Phase 2 Final Design Report for 2013

Addendum No. 3 – CU59 and CU60 Design Revisions

Hudson River PCBs Superfund Site

August 2013

FIGURE
1-1

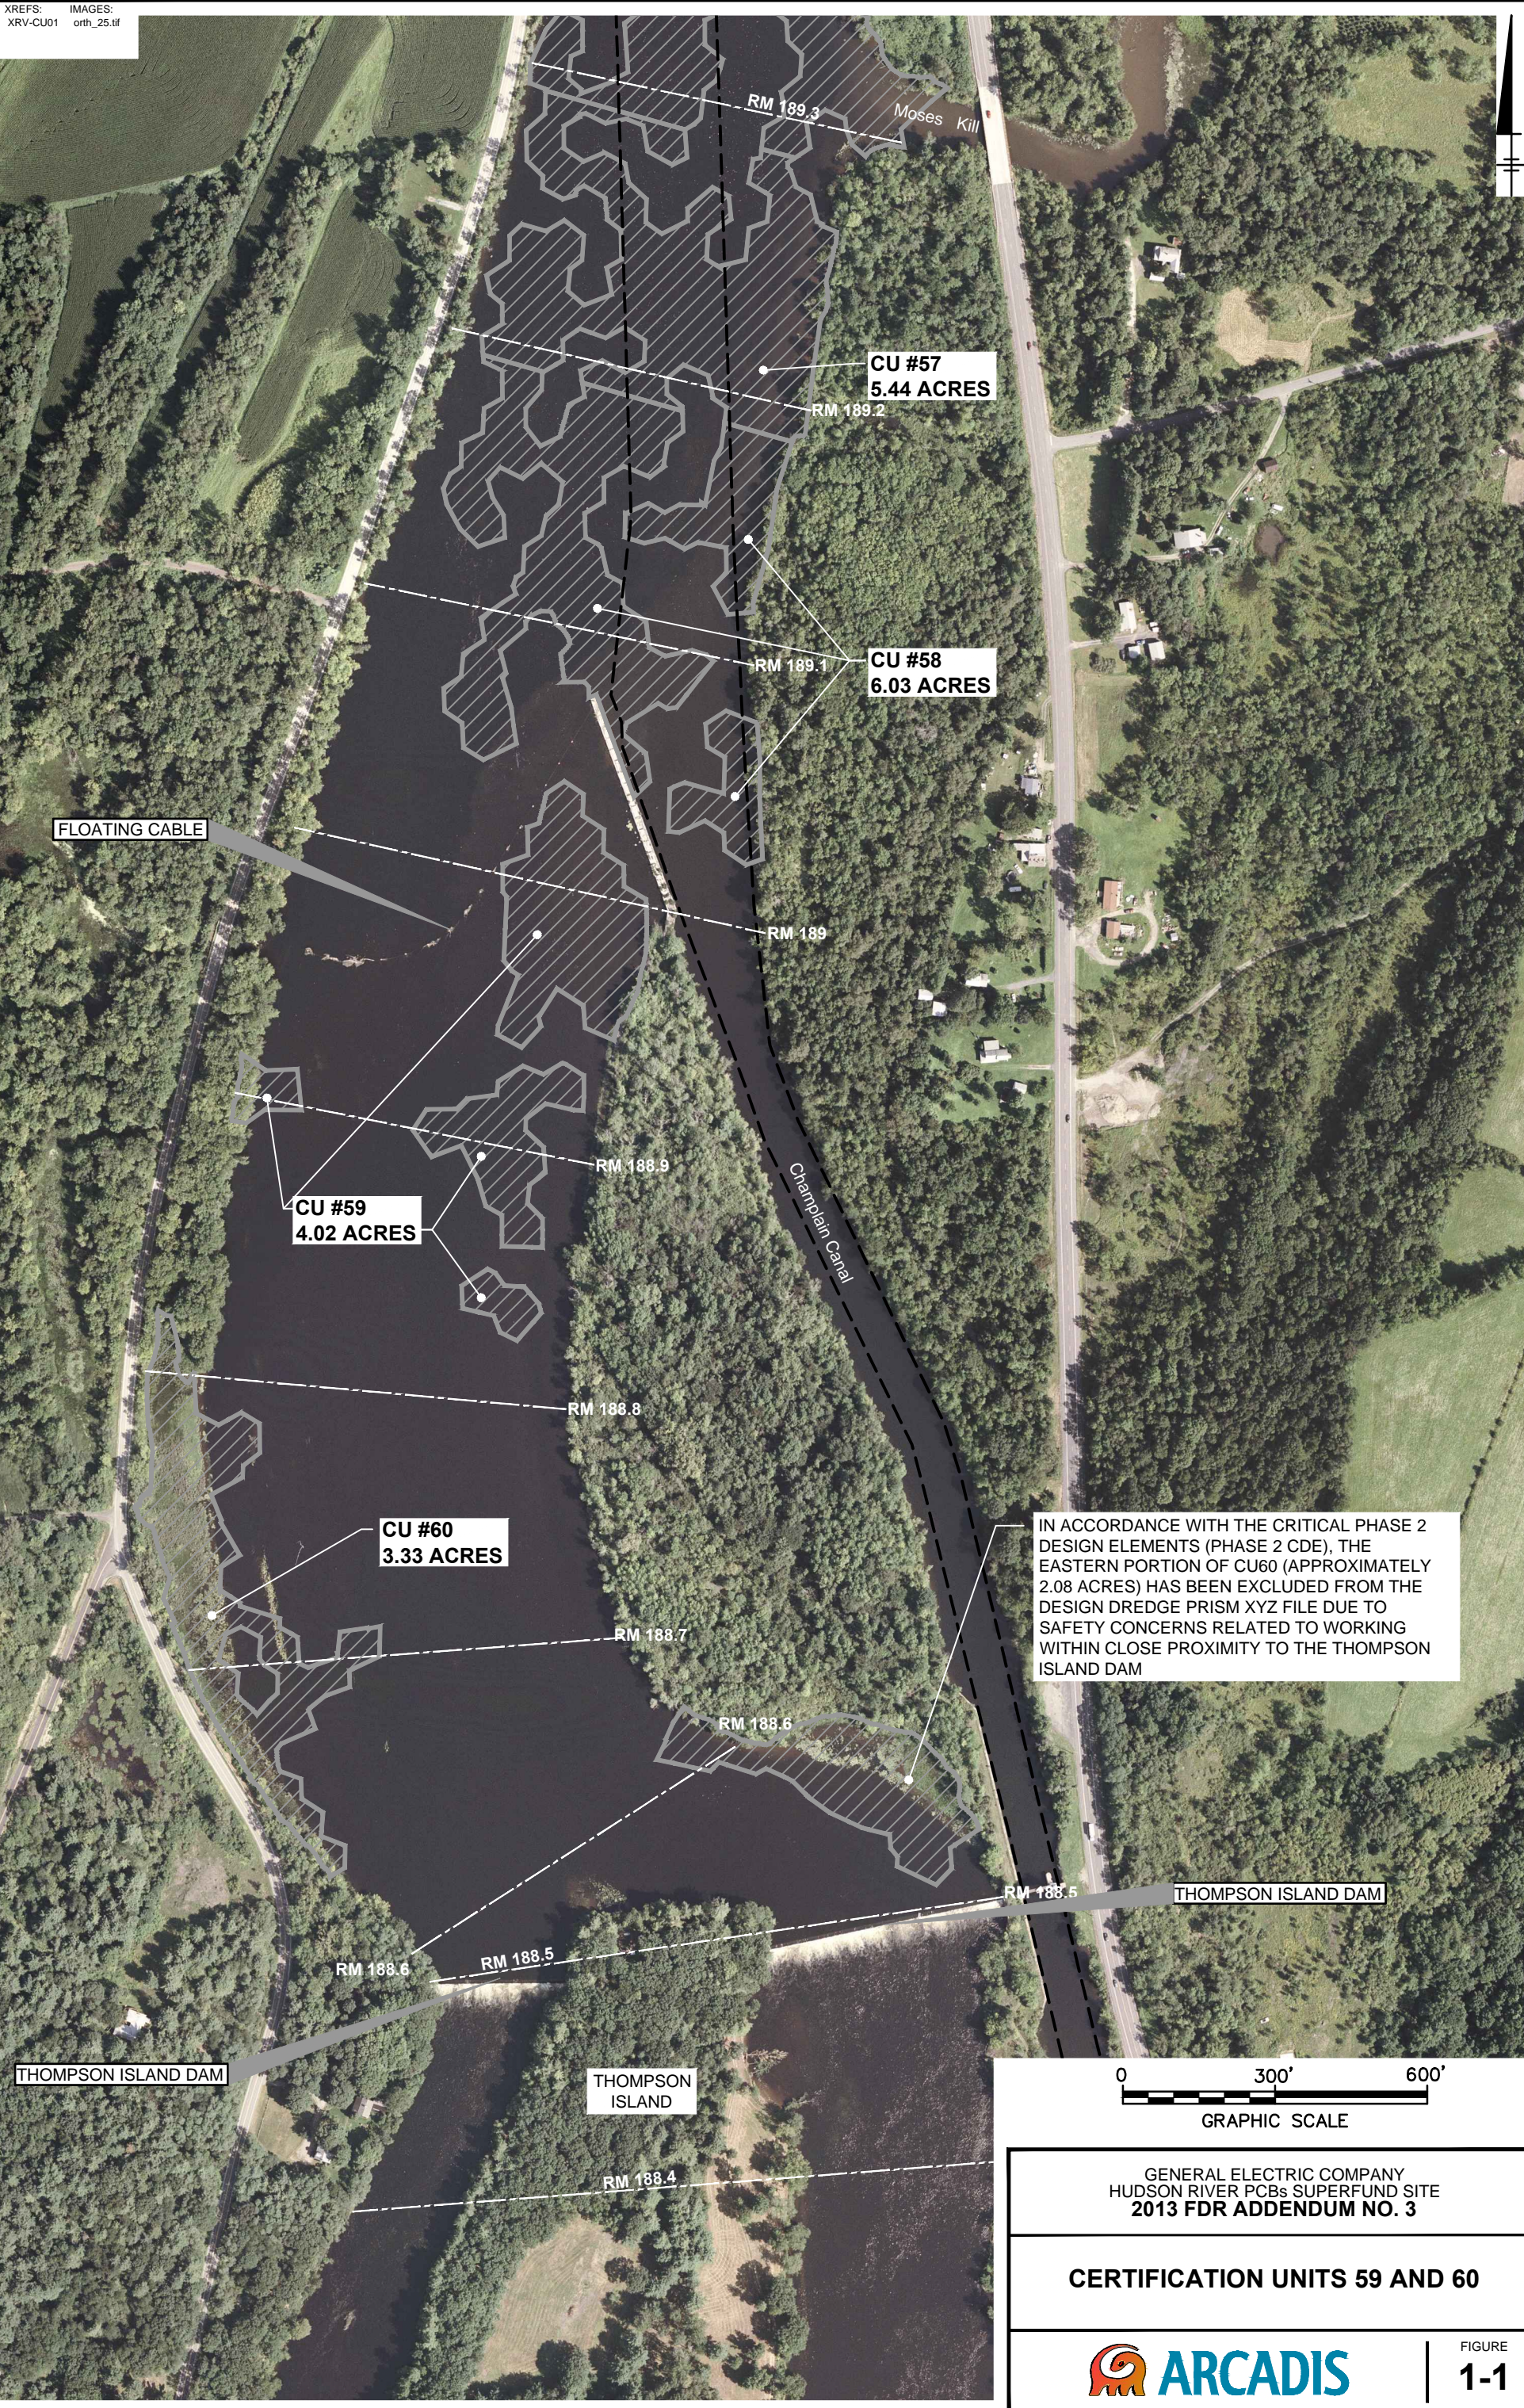
This report, prepared on behalf of the General Electric Company (GE), constitutes an addendum to the Phase 2 Final Design Report for 2013 (2013 FDR; ARCADIS 2013), which was approved by the United States Environmental Protection Agency (EPA) on May 1, 2013. This addendum (2013 FDR Addendum 3) presents certain design revisions for dredging operations to be conducted in Certification Unit (CU) 59 and CU60, located in Reach 8 immediately upstream of Thompson Island Dam, as shown on Figure 1-1.

Based on the results of the August 2013 survey, the shoreline boundary and the shoreline extent of CU60 were adjusted to correspond with the surveyed location of the 119 ft elevation. Electronic data files with the updated shoreline coordinates and the updated CU boundaries are provided on the CD-ROM included with this addendum. The updated shoreline and CU boundaries have been incorporated into the revised Contract 42A drawings included in Appendix 2.
